ALASKAN WAY VIADUCT

EVALUATION OF GRAY'S RETROFIT PROPOSAL

Prepared for the
Washington State Department of Transportation

By
T.Y. Lin International

Figure D.8 Column curvature versus axial force, retrofitted structure, rare earthquake, middle bents

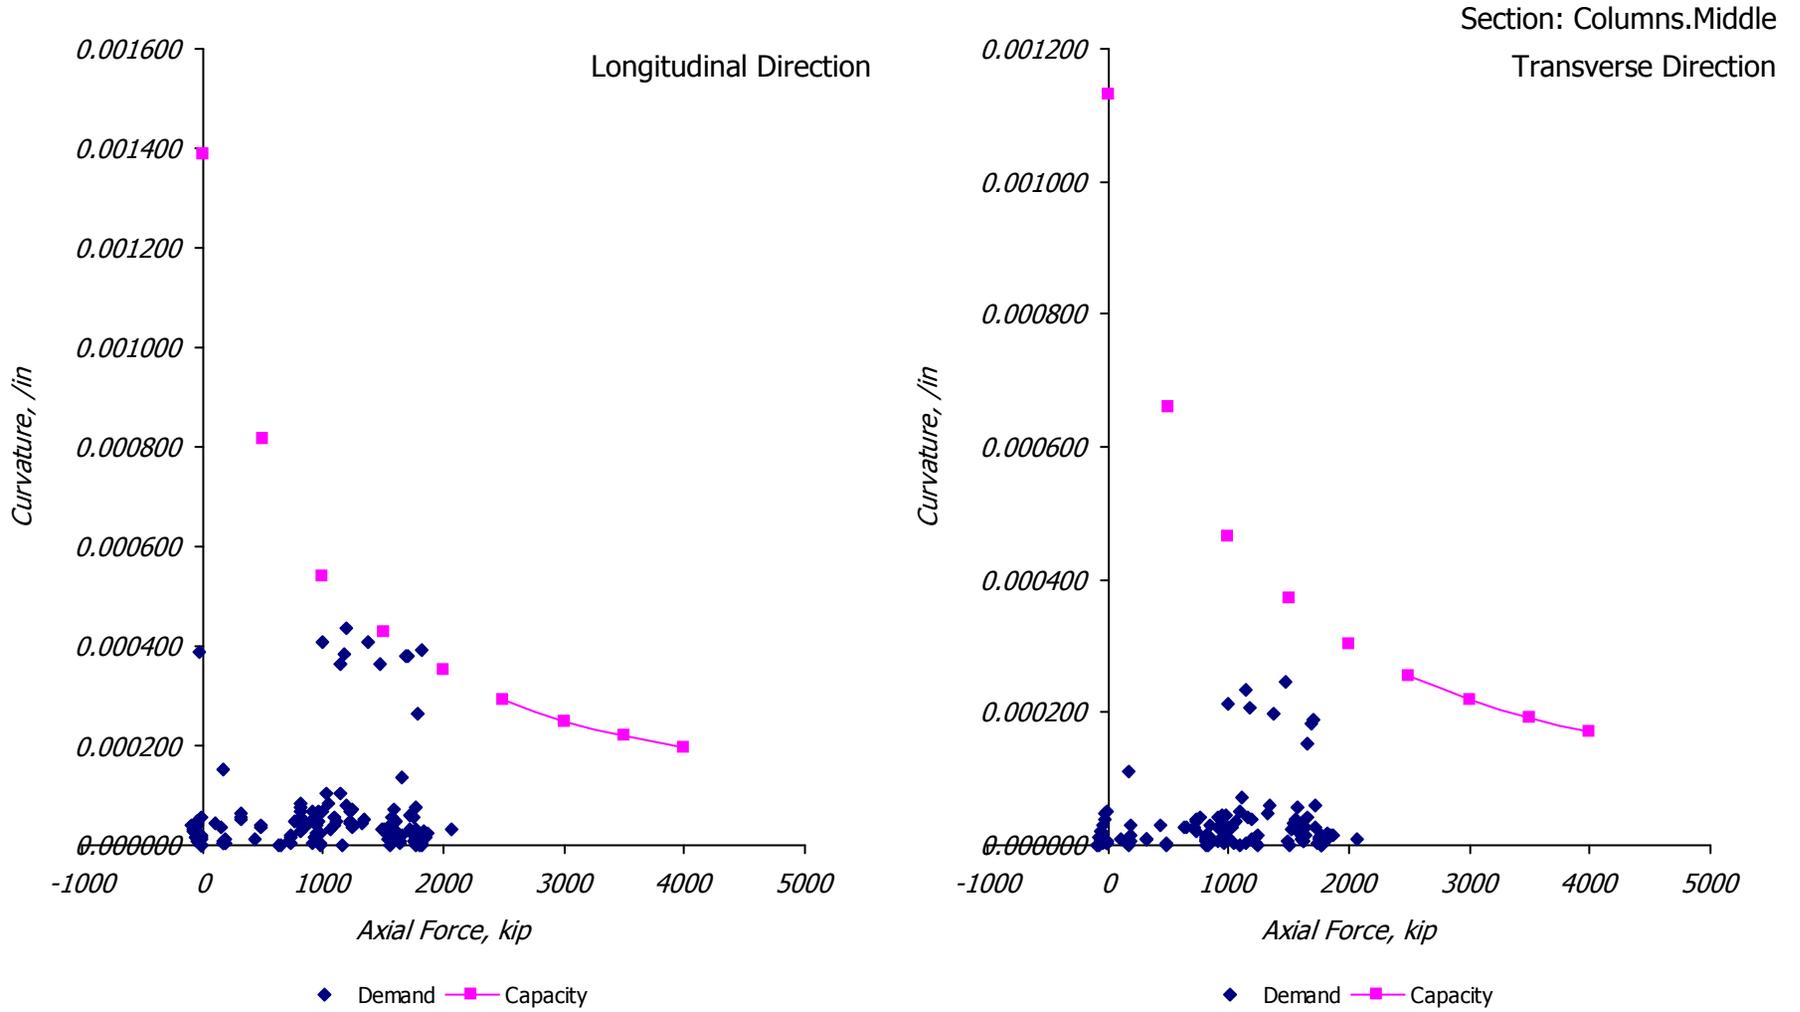
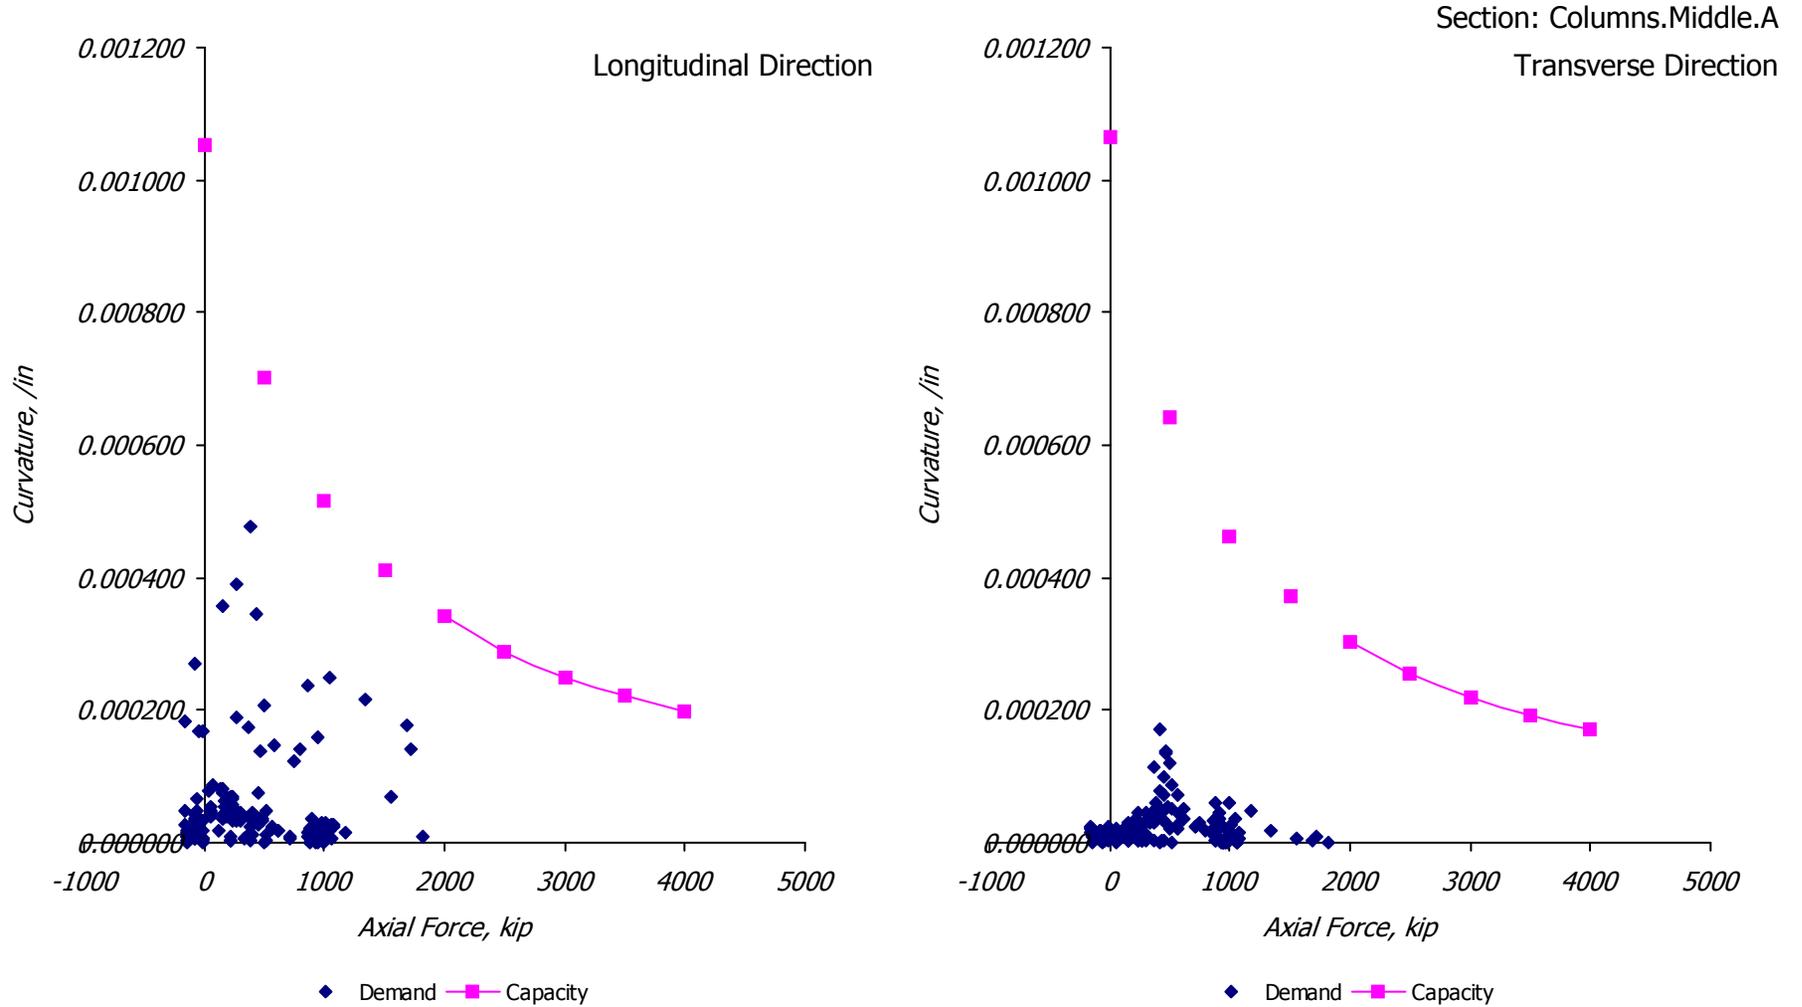
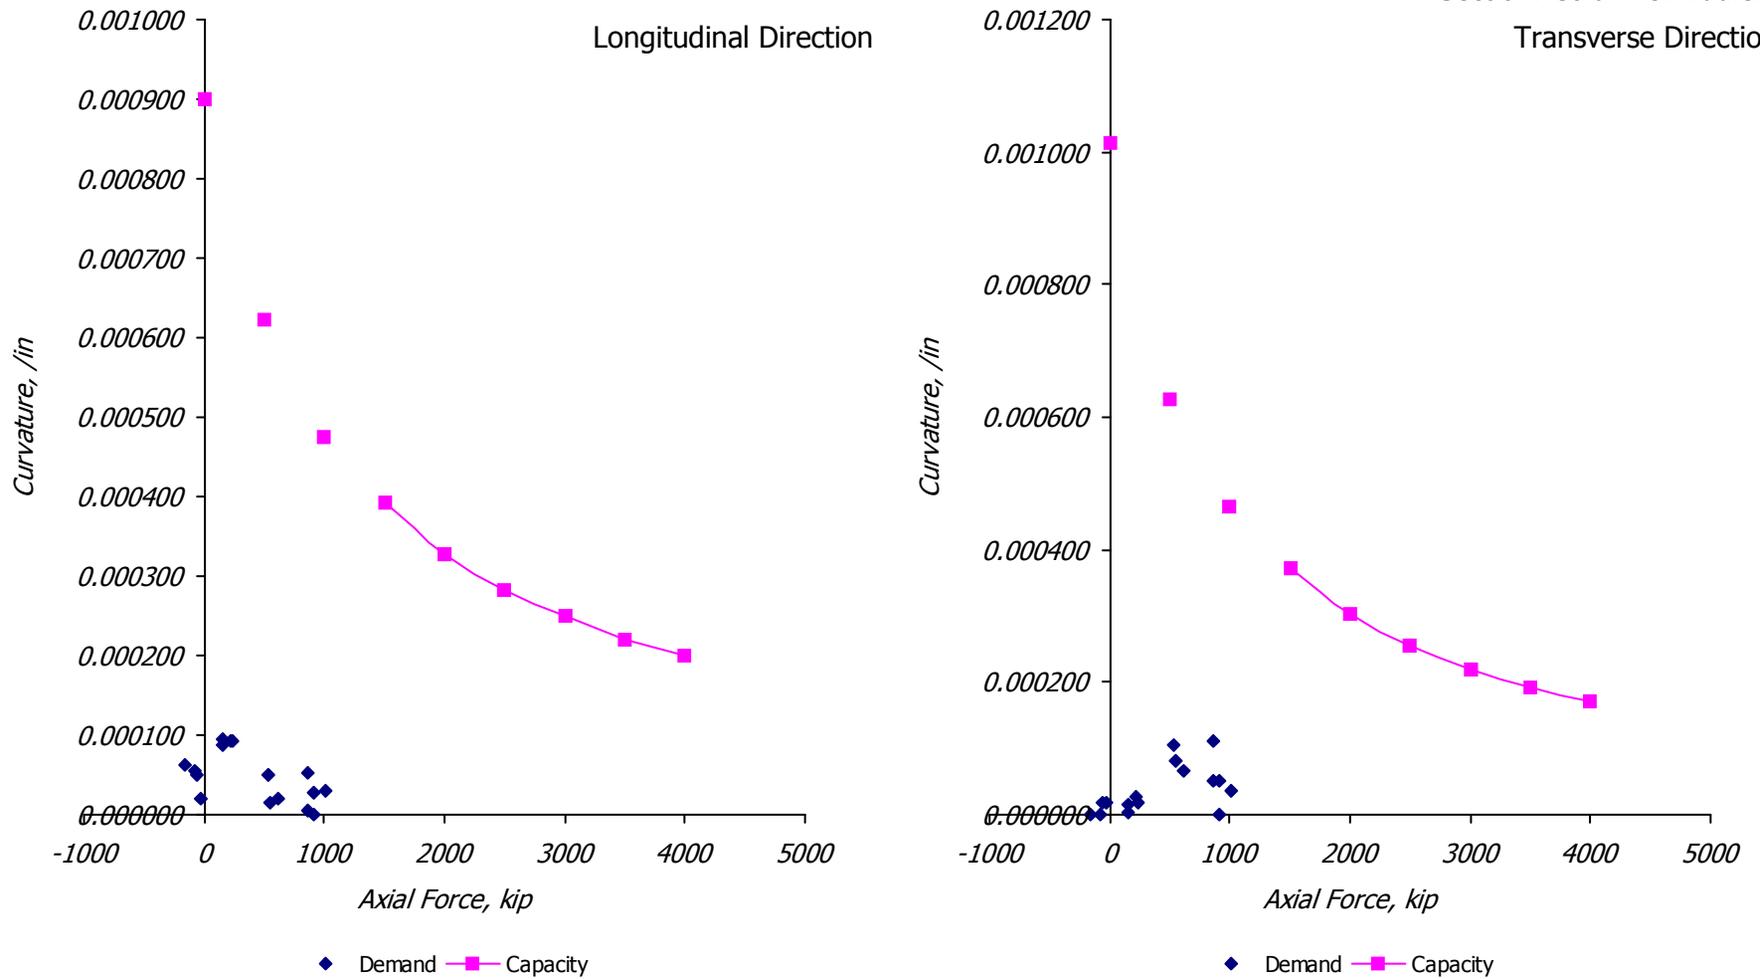
Figure D.8 shows that the flexural demands on the middle columns slightly exceed the capacity in the longitudinal direction, for the section designated “Columns.Middle” (the typical section). (In design, one would insist of a significant margin between the calculated demands and the capacity, to compensate for uncertainty in either analysis or capacity evaluation.) Figures D.7 and D.8 compare the demands to the capacity of the *existing* structure. Miyamoto’s proposal does include improvement of the flexural and shear capacity of the columns by wrapping them with ductile fiber wraps. The results presented herein indicate that some such retrofit is required. We have not evaluated the effectiveness of retrofit with fiber wrap, however.

Figure D.9a Column curvature ductility demand, retrofitted structure, design earthquake, longitudinal direction

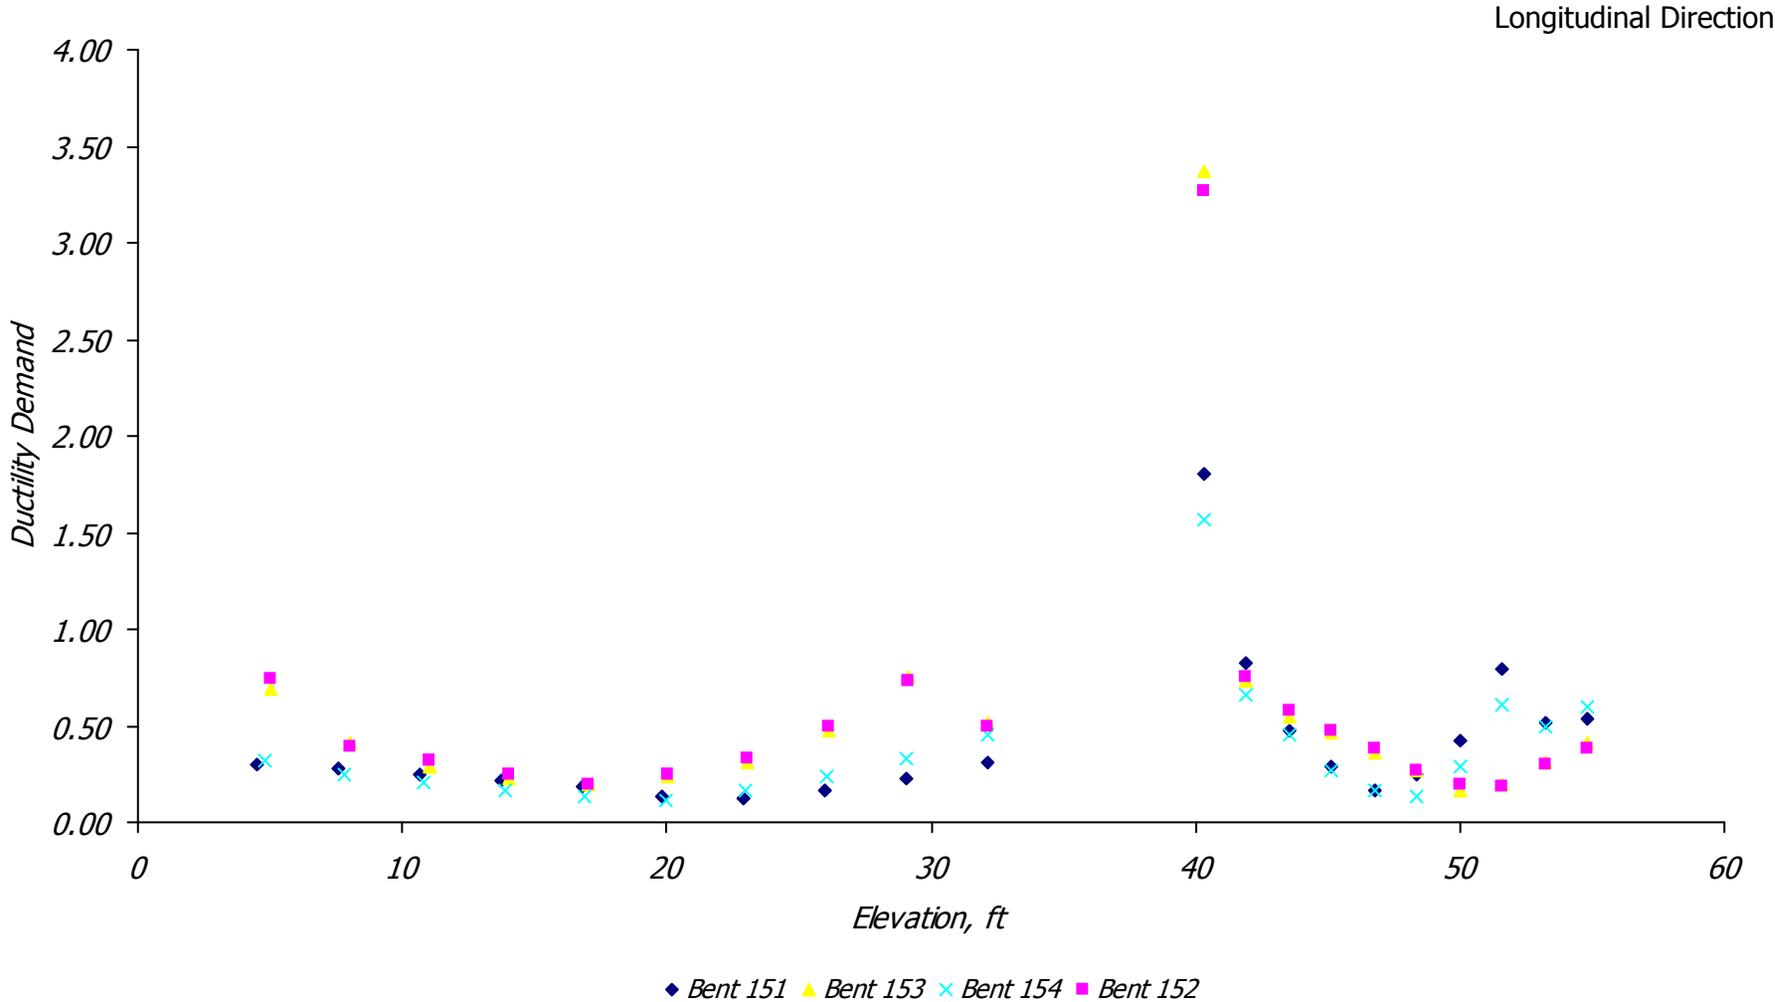
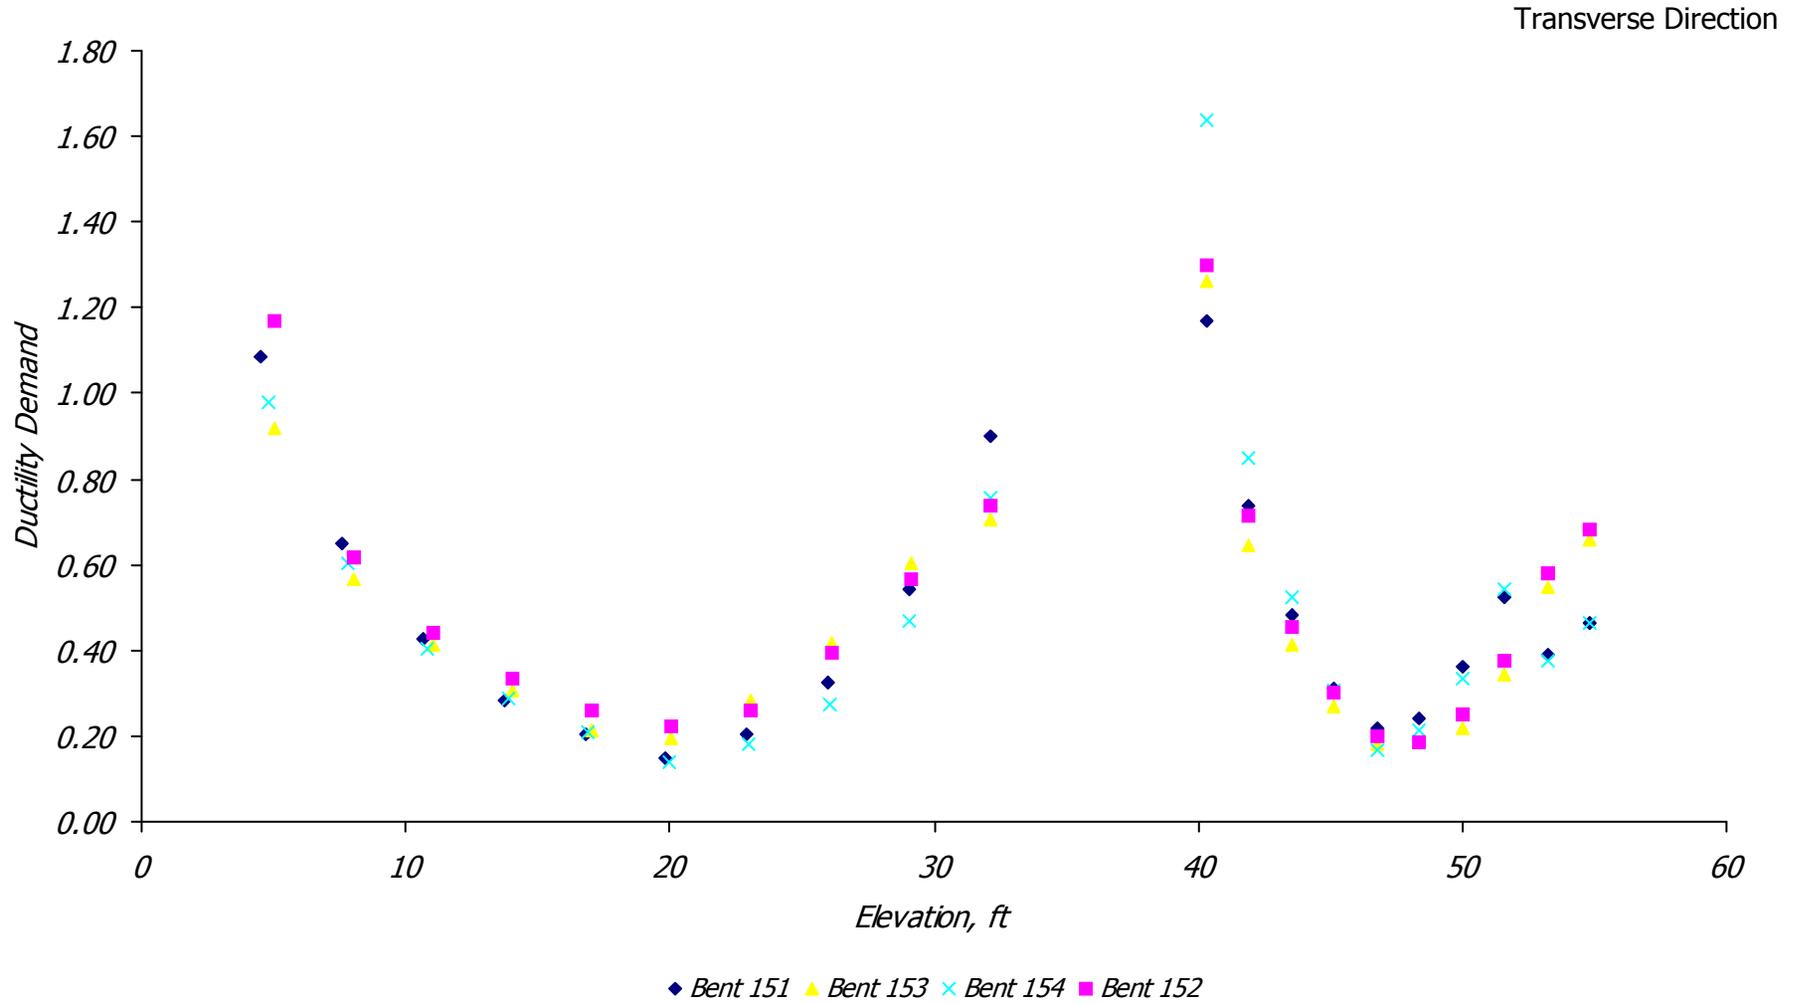
For the design earthquake, the curvature ductility demands on the columns are summarized in Figure D.9. These demands are consistent with repairable damage. Some degradation of the reinforcing bar splices in the upper columns may be expected unless the columns are retrofitted, say with fiber wrap.
